CCK-2583.2-1-24 Nutter Field House Gymnastics ADDENDUM # 1 9/18/2023

Nutter Field House Gymnastics JRA Project No. 202305 UK Project CCK-2583.2-1-24 University of Kentucky Lexington, Kentucky

The Addendum will form a part of the Contract Documents and modifies the original Bidding Documents dated September 2023.

**M-200**

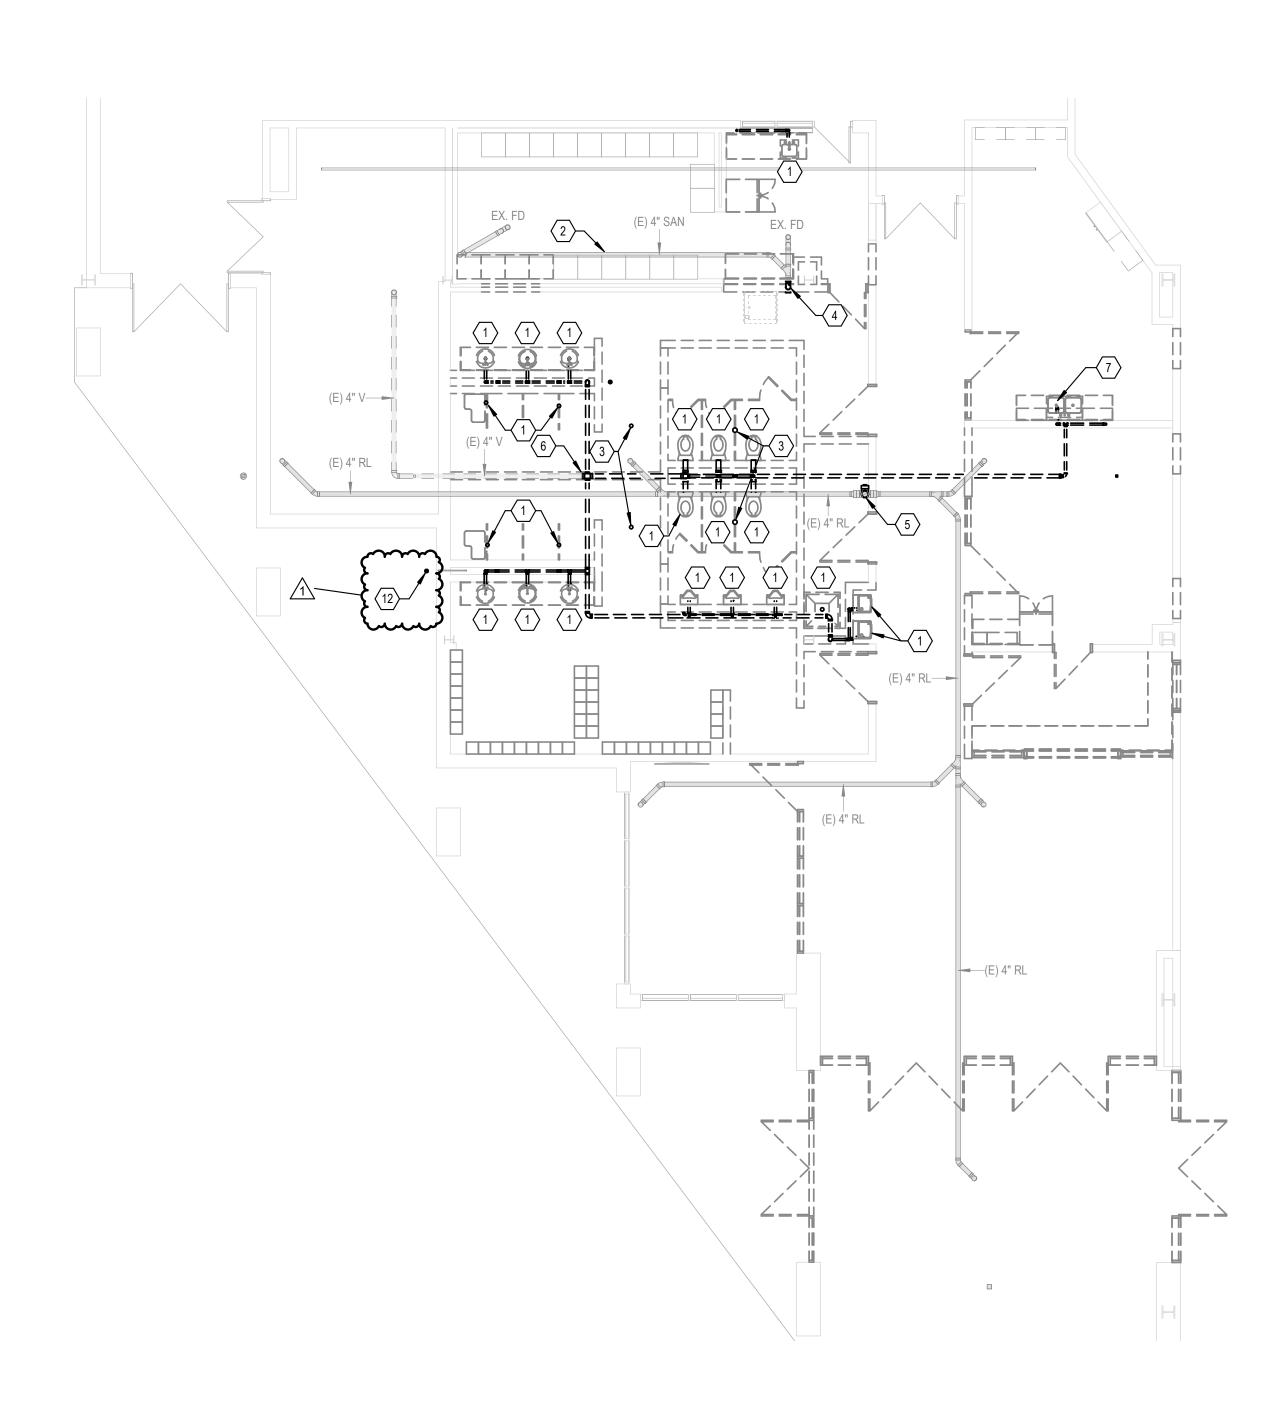
Added existing Invert Elevation for connection to existing sanitary main.

M-201

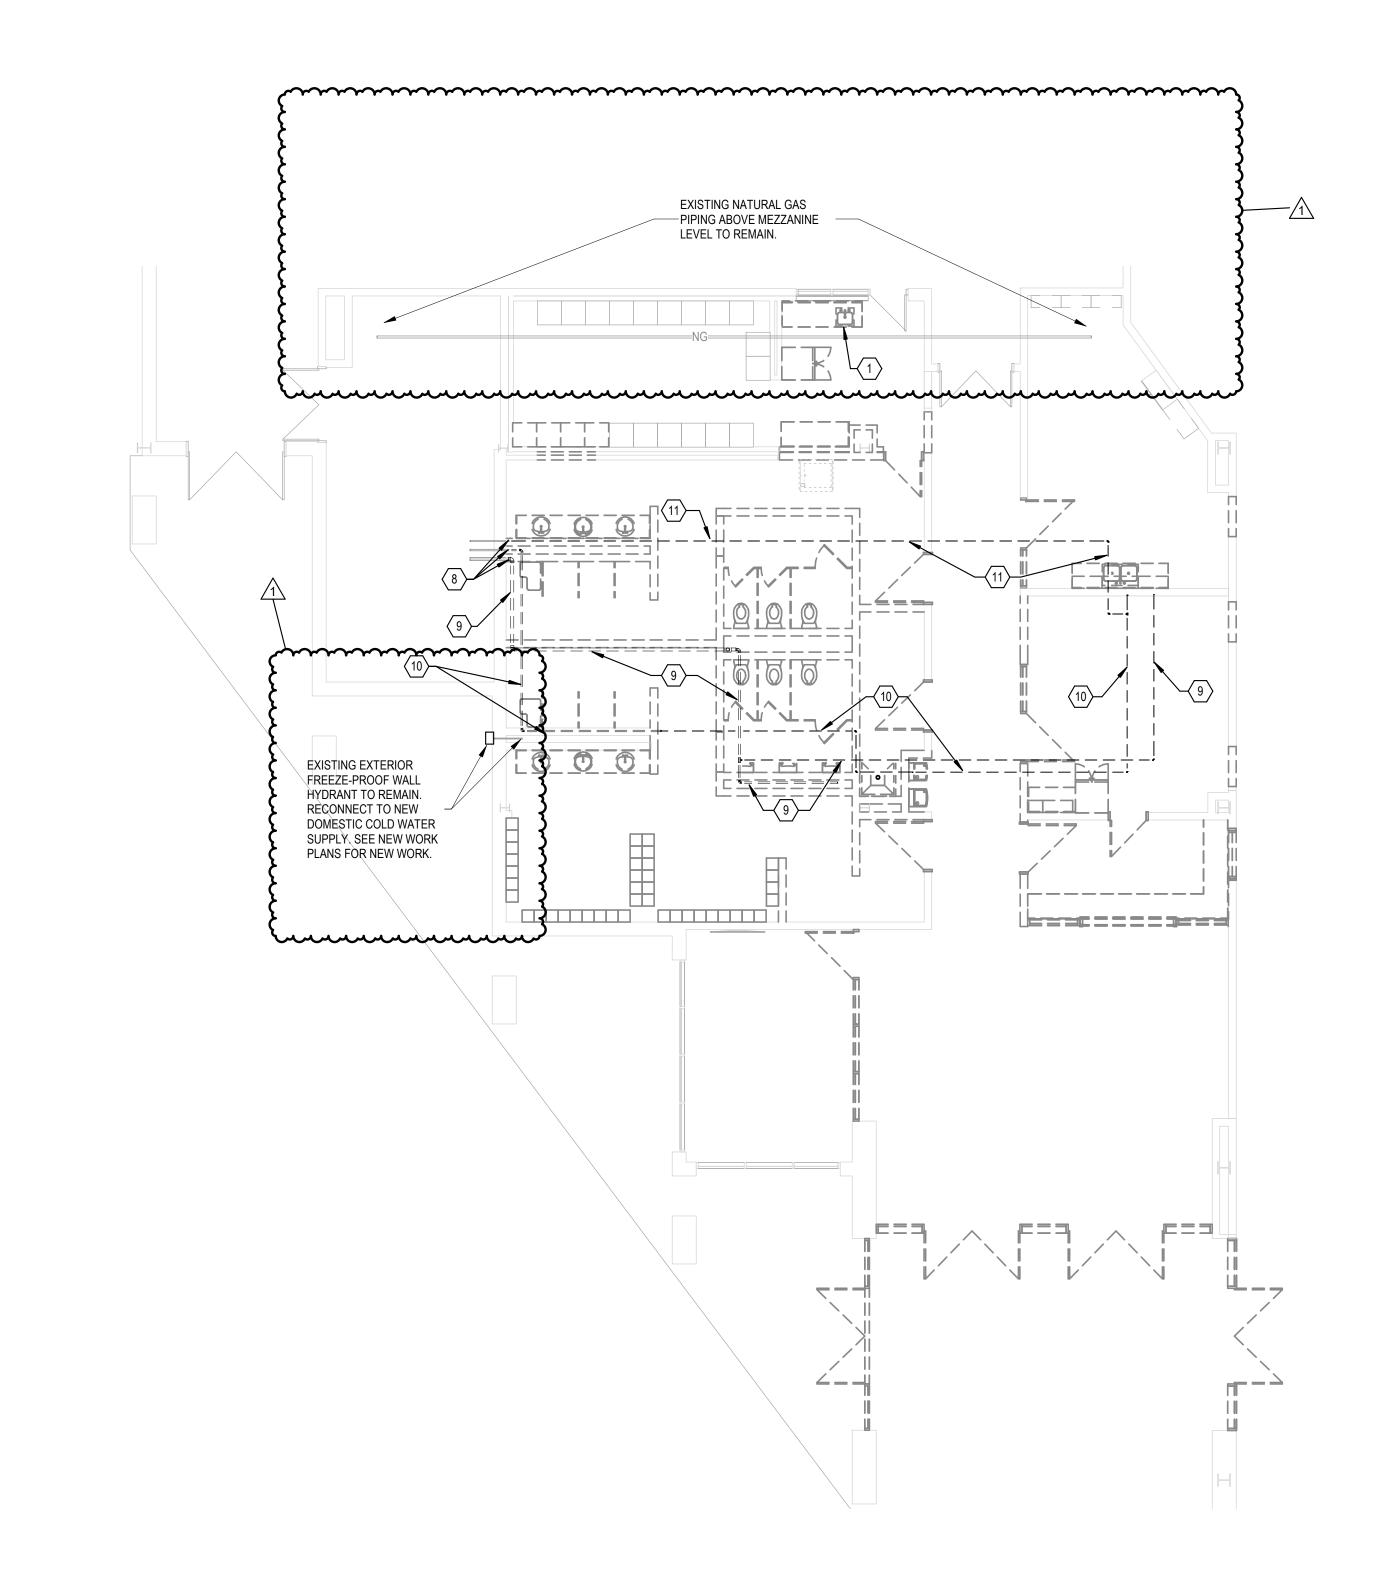
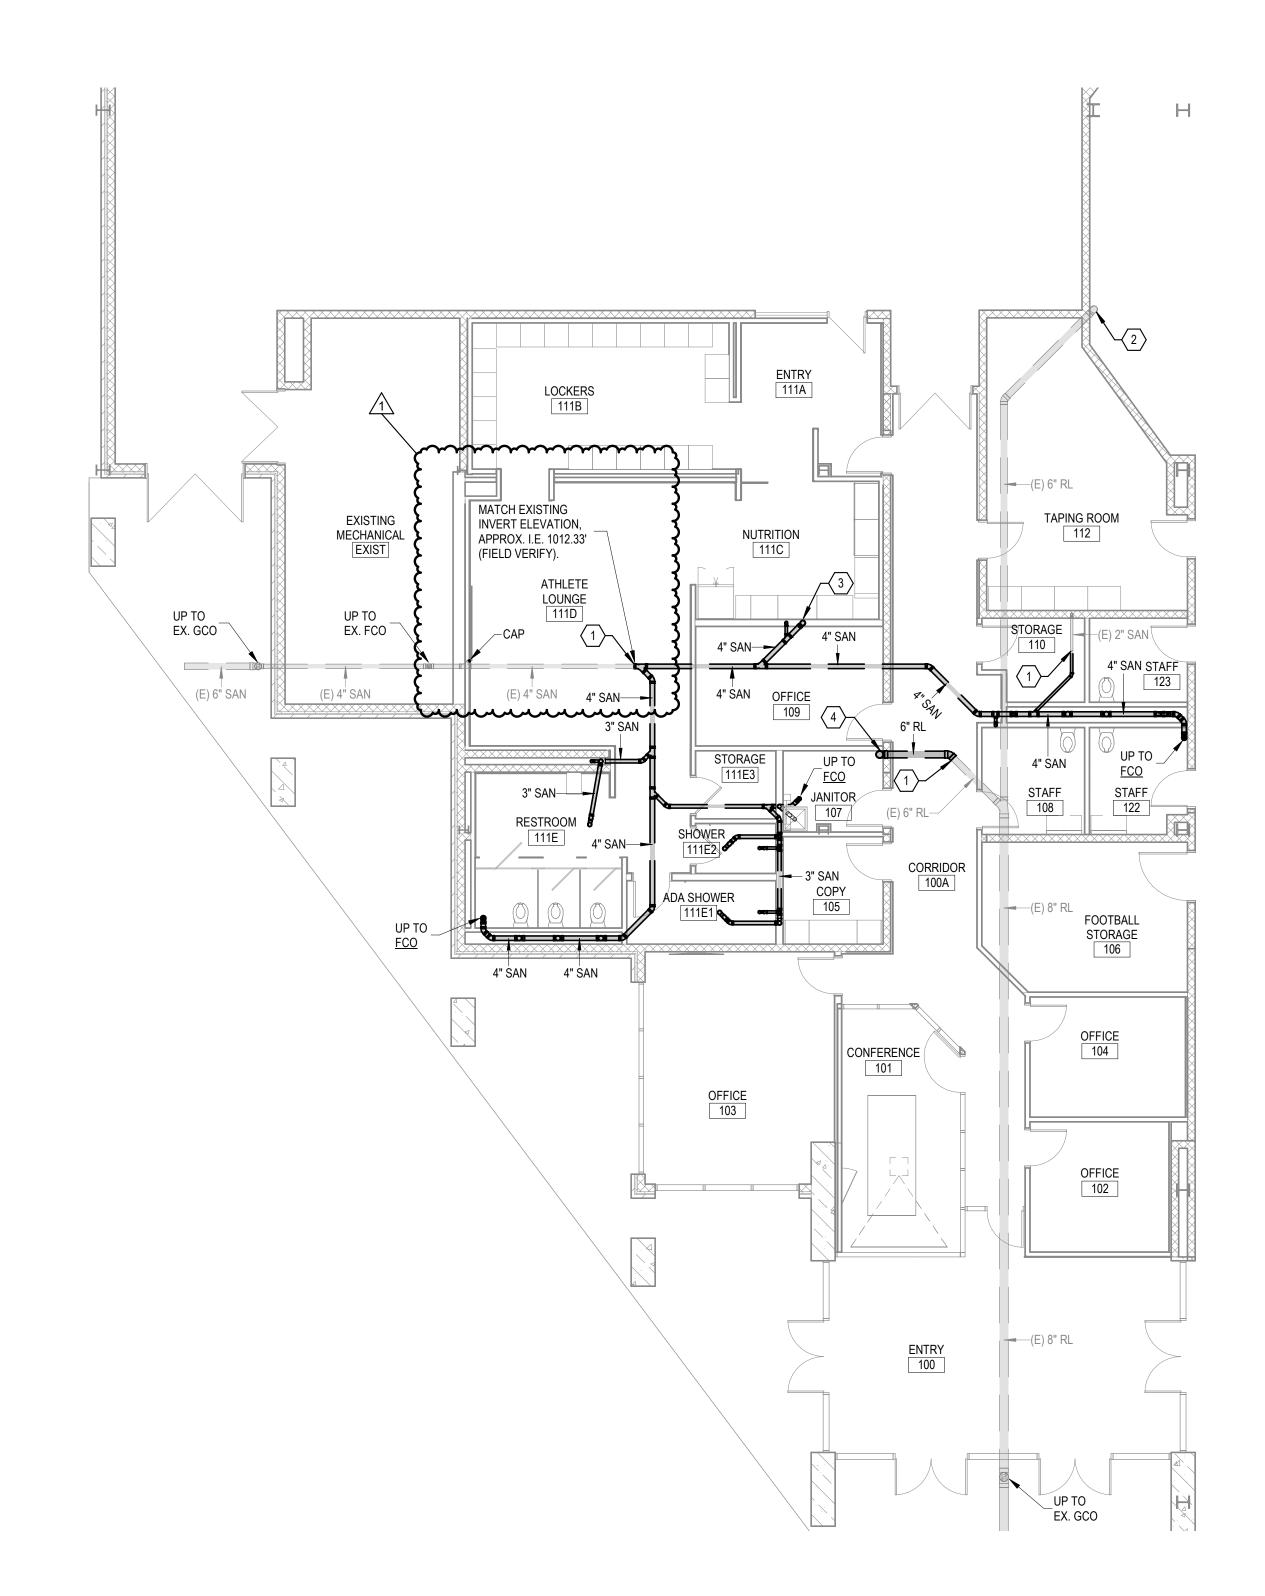
- Added note to clarify existing wall hydrant to remain.
- Added Coded Note to clarify removing existing grade cleanout.
- Showed existing natural gas piping to remain.

M-202

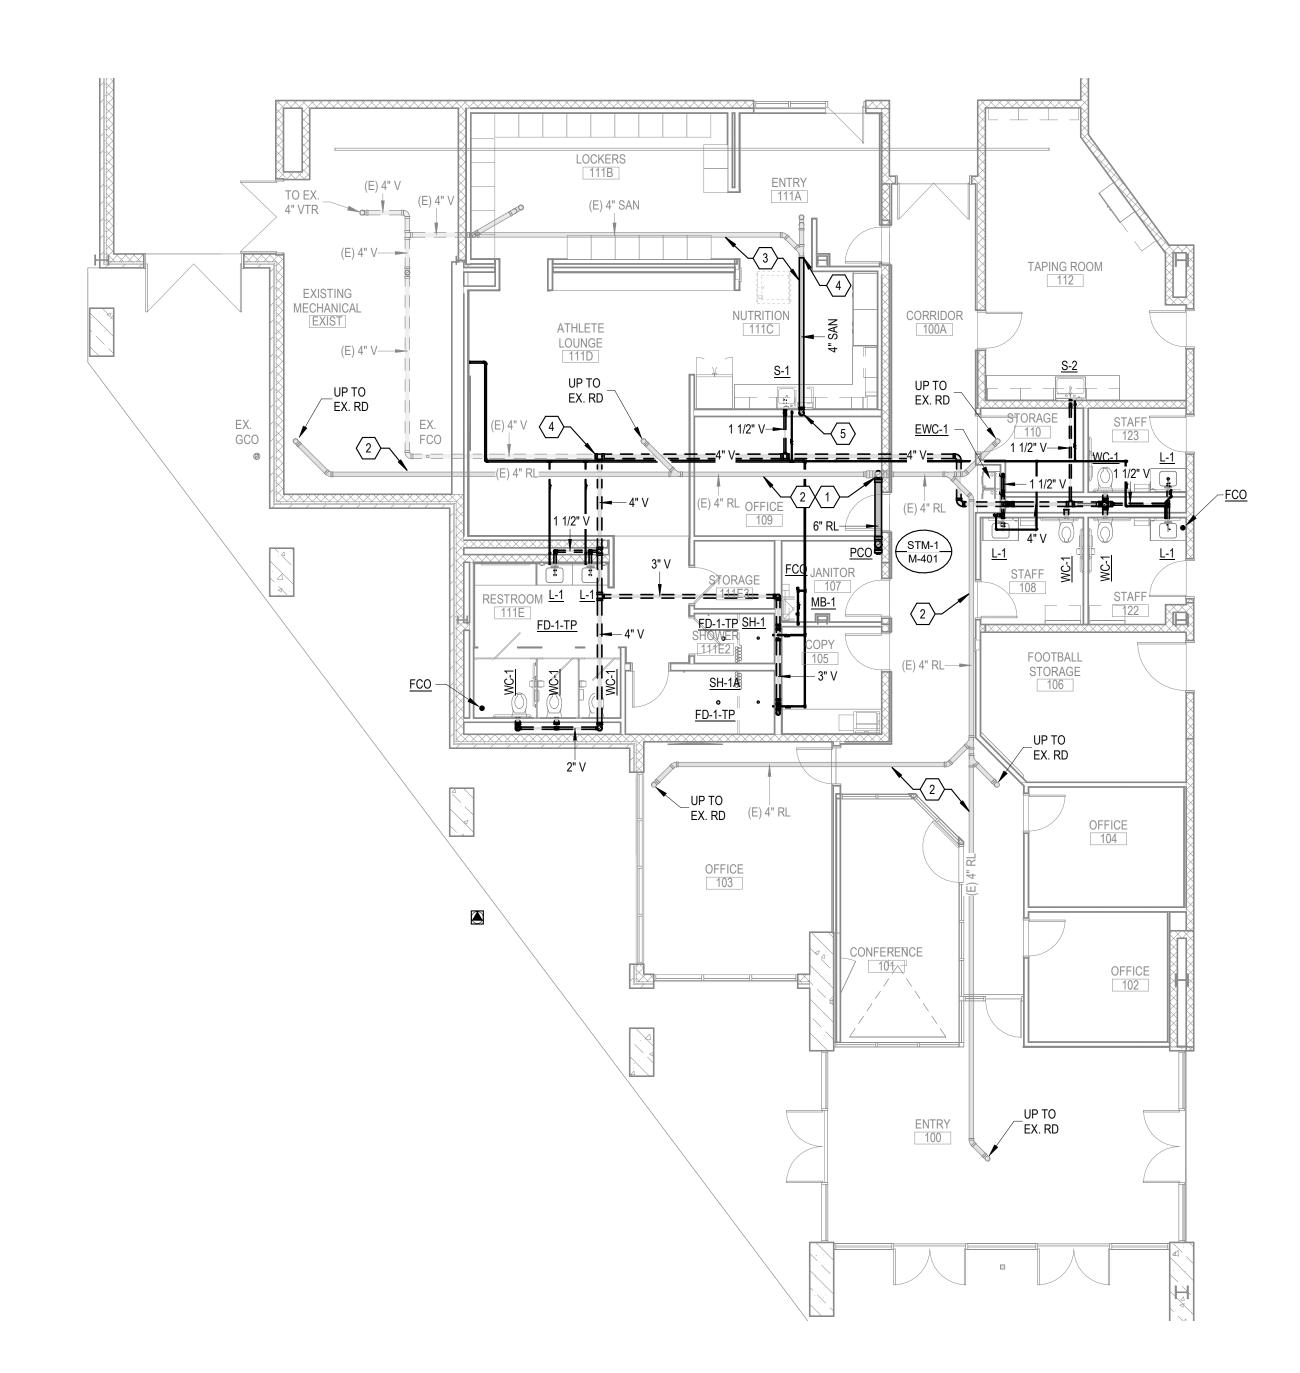
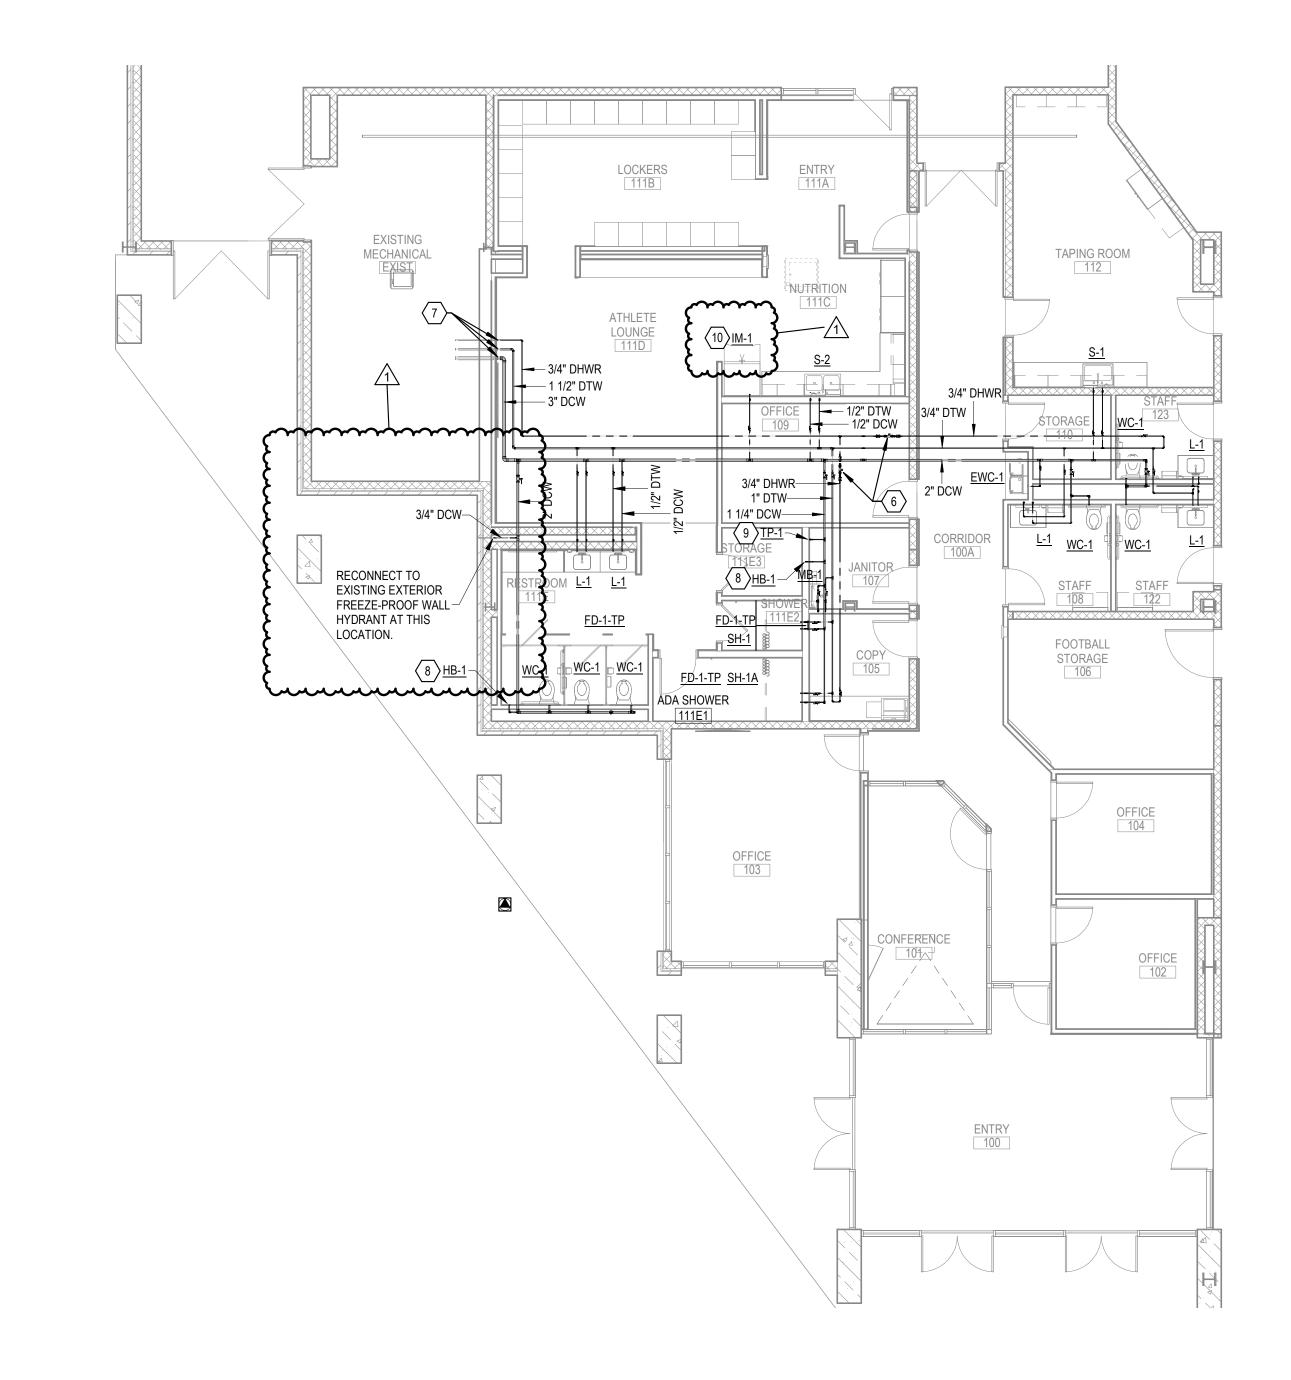
Added existing Invert Elevation for connection to existing sanitary main.

| CCK-2583.2-1-24 |                           |      |  |             |   |  |  |
|-----------------|---------------------------|------|--|-------------|---|--|--|
| 3               | 9/11/2023                 |      | What is the max depth of the existing 4" Sanitary Line to be tied into? Will the floor need to be scanned before cutting and digging to reach the existing line? | KFI         | Match existing elevation, approx. 1012.33' (field verify).  |  |  |
